TRANSMISSION 722.7 in MODEL WDB168.### ## as of 548031 as of 10.1.01

P27.60-2187-06

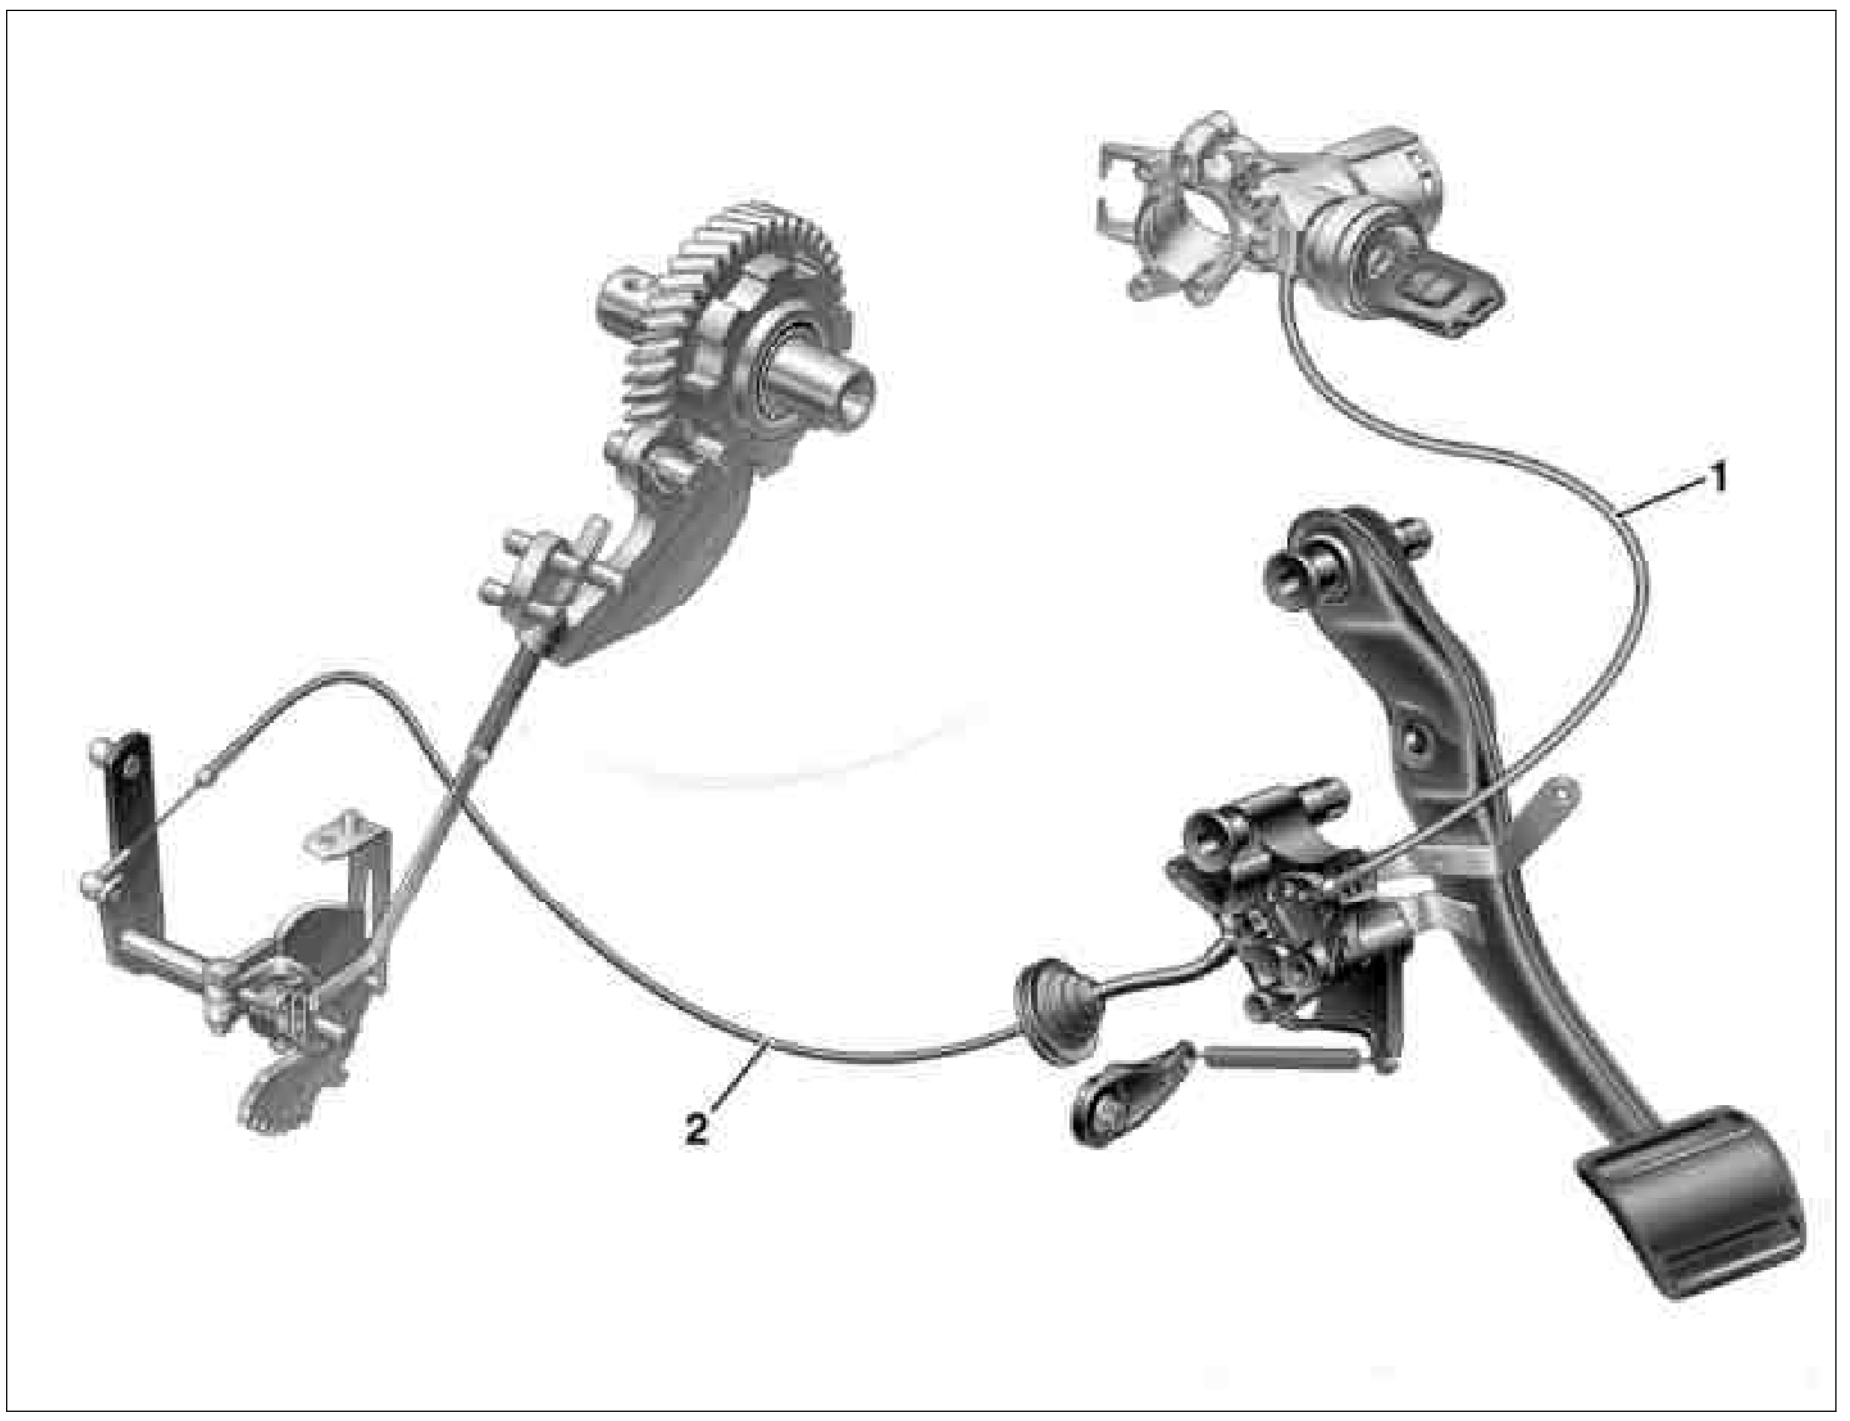
1 New ignition lock cable
2 Shift lock cable

For cost-saving reasons the shift lock cable of the ignition lock to transmission is discontinued. A cable from the ignition lock to the brake pedal is used in its place. **Consequently, it is only possible to withdraw the ignition key when the brake pedal is depressed**.
The new ignition lock cable (1) does no longer require to be adjusted.
